# Access Compliance Report

## Public Rights-of-Way

Intersection ID: 52582	Main Street: NOBLES_AV	Cross Street: N/A	Location: NW
ADA ID: 7E344A5A6C77	Ramp Type: Perp	Initial Pass/Fail: Fail	Overall Compliance: No
		Severity Score: 1.25

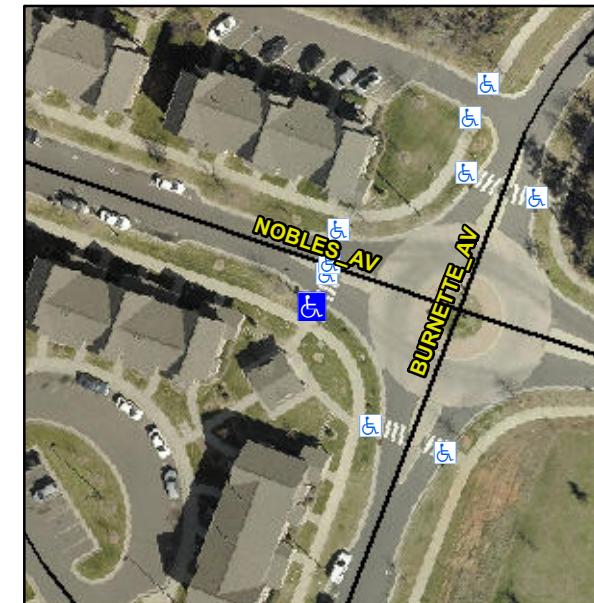
**Not Found, R304.5.3**

Compliance	Description	Data	Compliance	Description	Data
N/A	Ramp Length (in)	56.0	Yes	Ramp Slope (%)	7.4
Yes	Ramp Width (in)	70.0	No	Ramp XSlope (%)	3.1
N/A	Flare Type LT	N/A	N/A	Flare Type RT	N/A
N/A	Flare Slope LT (%)	N/A	N/A	Flare Slope RT (%)	N/A
N/A	Flare Traversable LT?	N/A	N/A	Flare Traversable RT?	N/A
N/A	Landing Length (in)	N/A	N/A	DWS Provided?	N/A
N/A	Landing Width (in)	N/A	N/A	DWS Contrast?	N/A
N/A	Landing Slope (%)	N/A	N/A	DWS Length (in)	N/A
N/A	Landing X Slope (%)	N/A	N/A	DWS Full Width?	N/A
N/A	Landing Curb? (Y/N)	N/A	N/A	DWS Offset (in)	N/A
N/A	Shared Landing?	N/A			
N/A	Gutter Ponding?	N/A	N/A	Gutter Slope (%)	N/A
N/A	Gutter Lip Ht (in)	N/A	N/A	Gutter X Slope (%)	N/A
N/A	Painted X Walk1?	Yes	N/A	Painted X Walk2?	N/A
	X Walk 1 Direction	To NE		X Walk 2 Direction	N/A
N/A	X Walk 1 Width (in)	118.0	N/A	X Walk 2 Width (in)	N/A
	X Walk 1 Slope (%)	2.1		X Walk 2 Slope (%)	N/A
	X Walk 1 X Slope (%)	2.0		X Walk 2 X Slope (%)	N/A

**Remove & Replace Entire Ramp.**
